AD. SHEET NO. 97-E 1932 15 45

SERIES F - No. 97-E
 SHEET 13 of 45

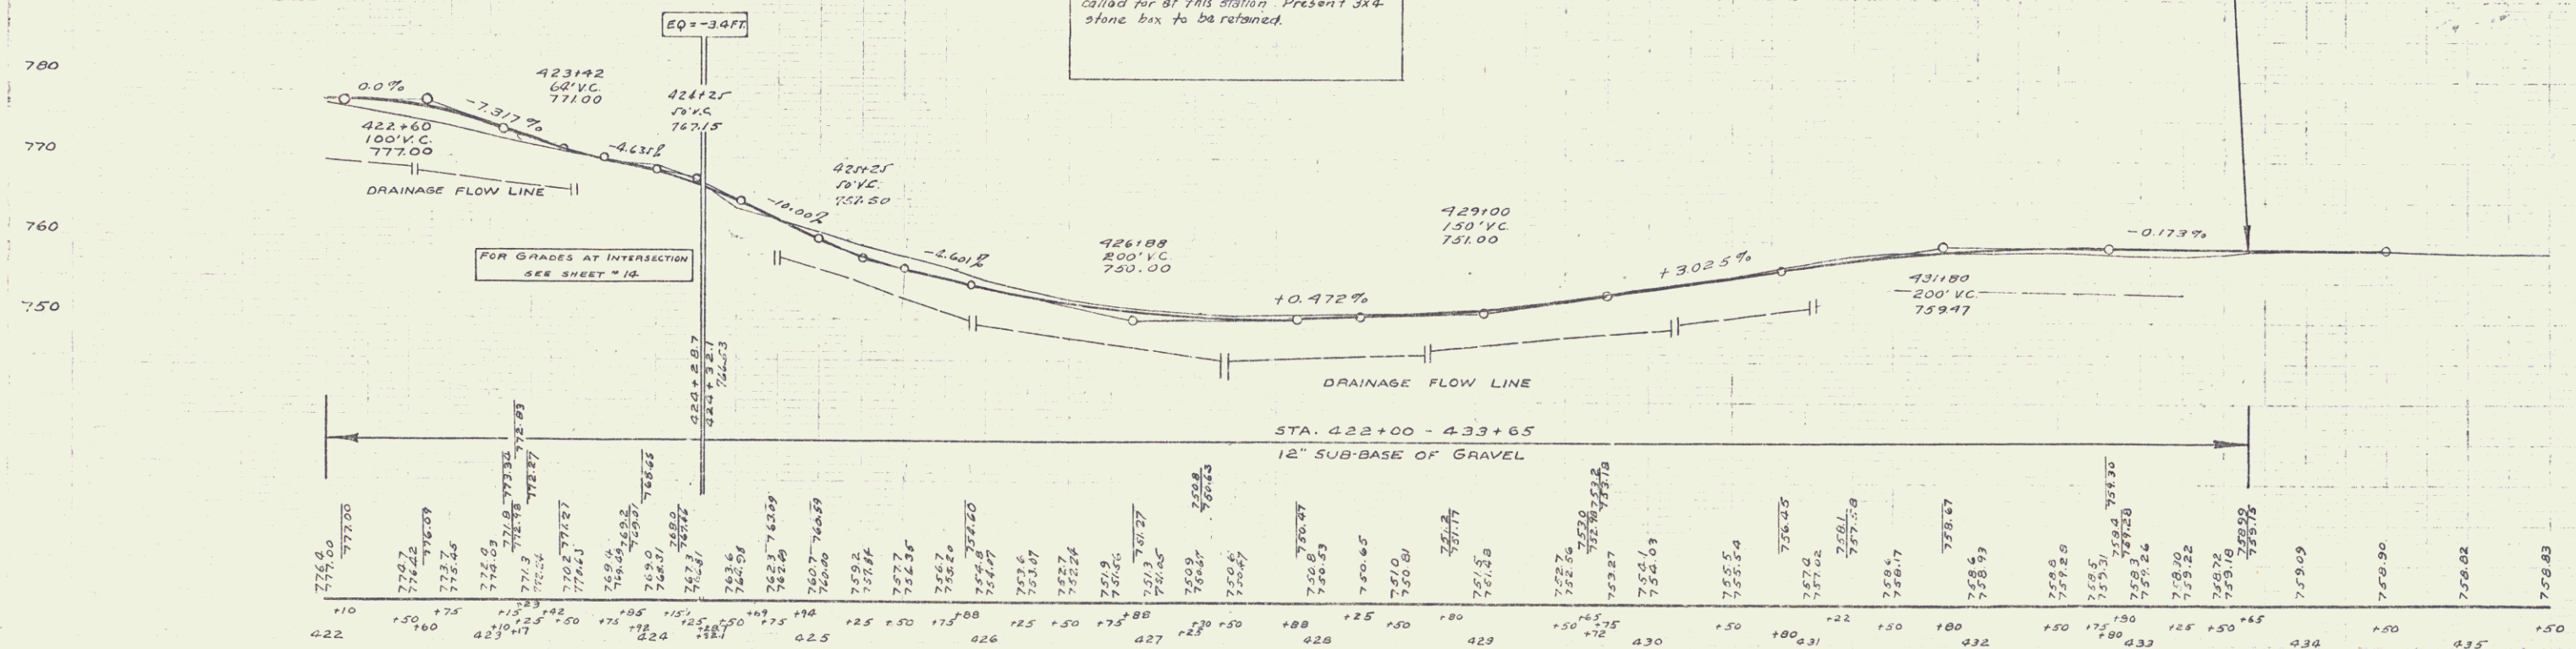
REVISIONS
 10/10/32. Brick Catch Basins at Sta. 423+12 & 423+70 replaced with 21\"/>
